CITY OF NAPOLEON  
BUILDING DEPT.  
Plan Approval  
By RJS Date 9/21/00  
CITY OF NAPOLEON  
BUILDING DEPT.  
Date

901  
Lynne

upper level  
1/4" = 1'-0"  
(outside walls 6" thick,  
inside walls 4" thick)

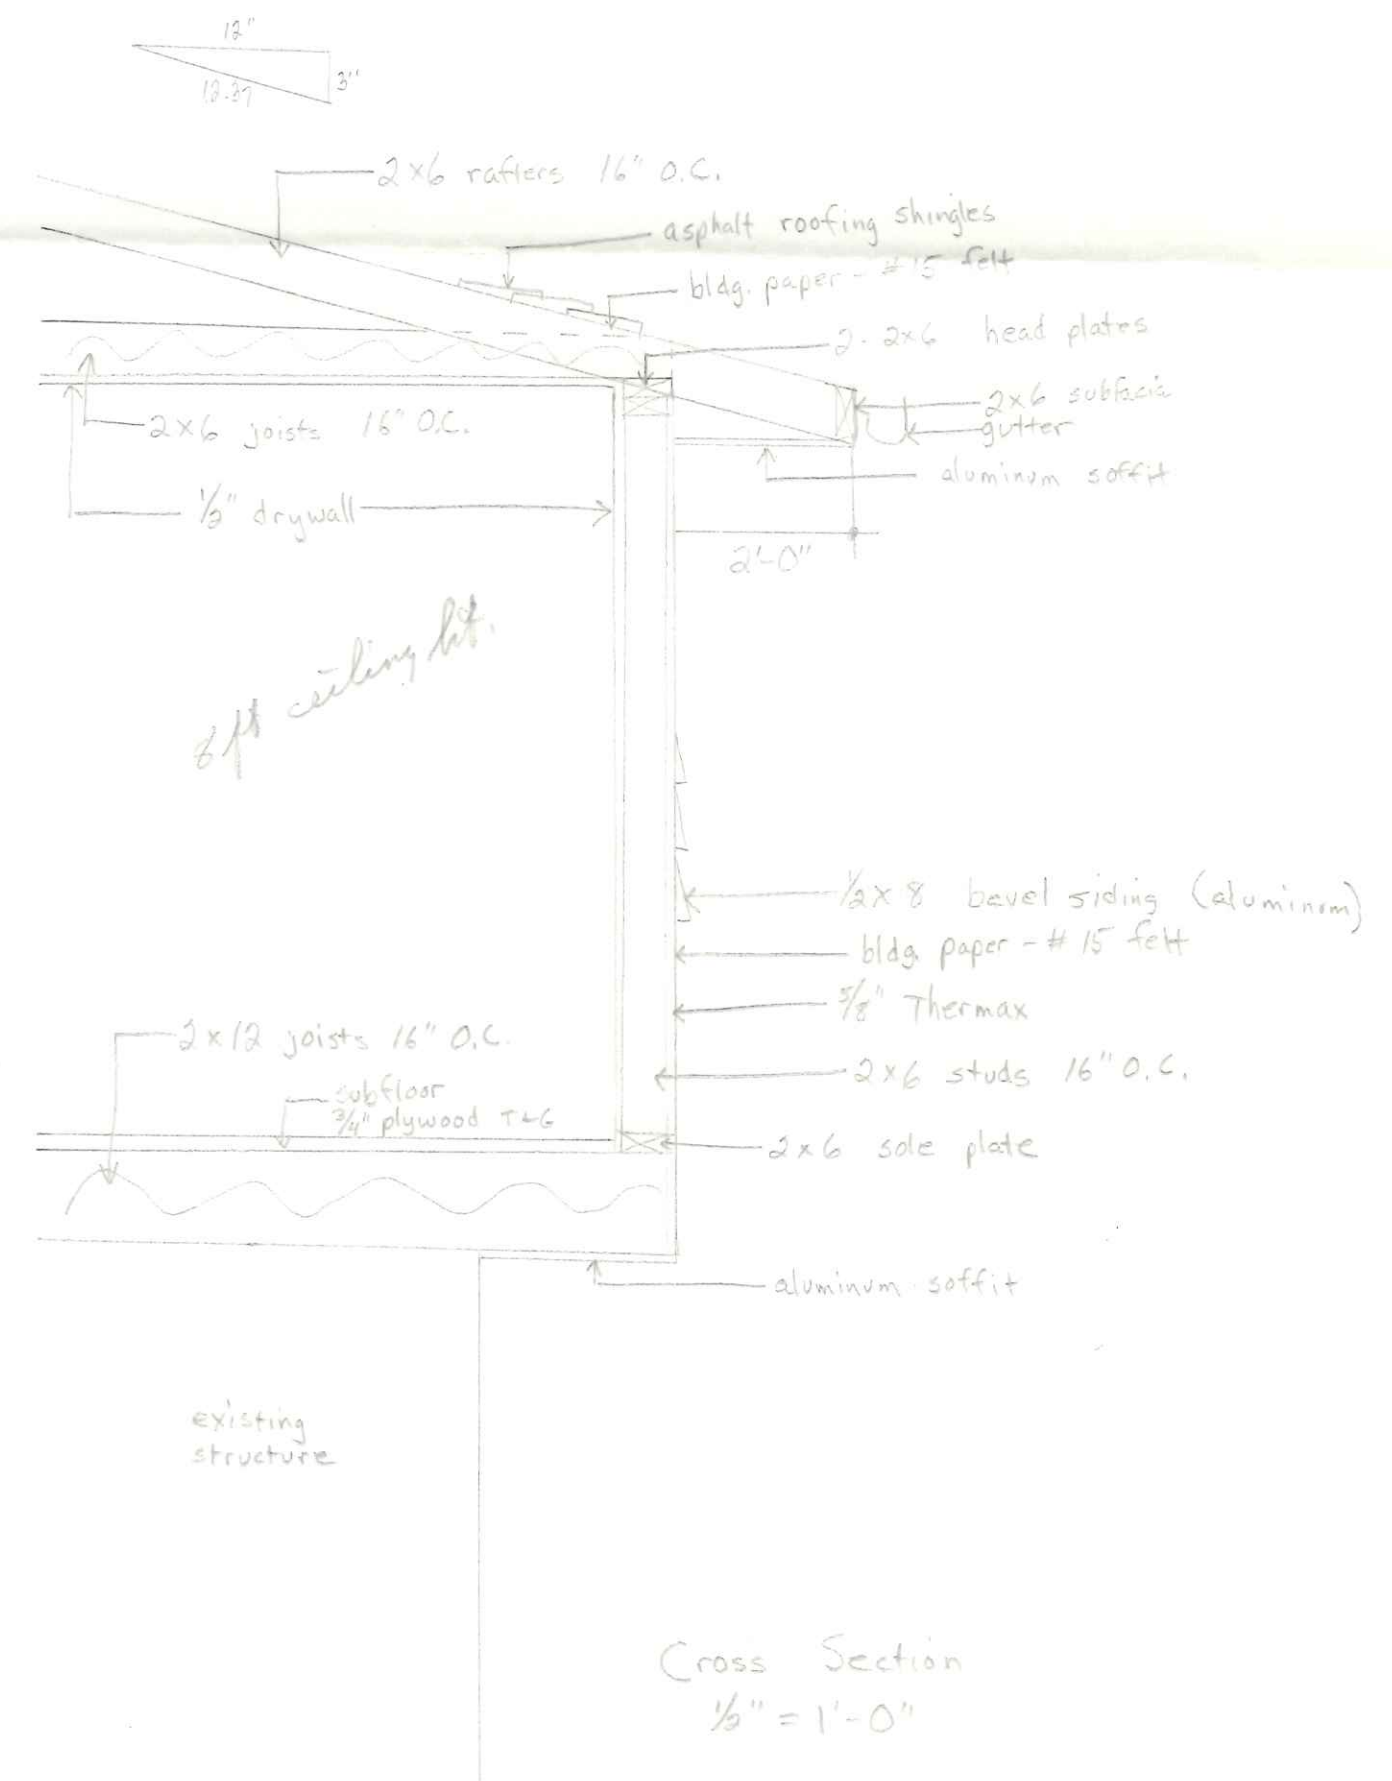
1. 1 CIRCUIT FOR LIGHTS
2. 4 TO 6 CIRCUITS FOR DUPLEXES
3. CHANGE SERVICE FROM 60A TO 100A
4. 2 BOX SYSTEM
5. Bath receptacles shall be on G.F.C.I.
6. Smoke Detector shall be installed at top of stairs
7. If bath has no window, fan shall be installed and ducted to exterior.
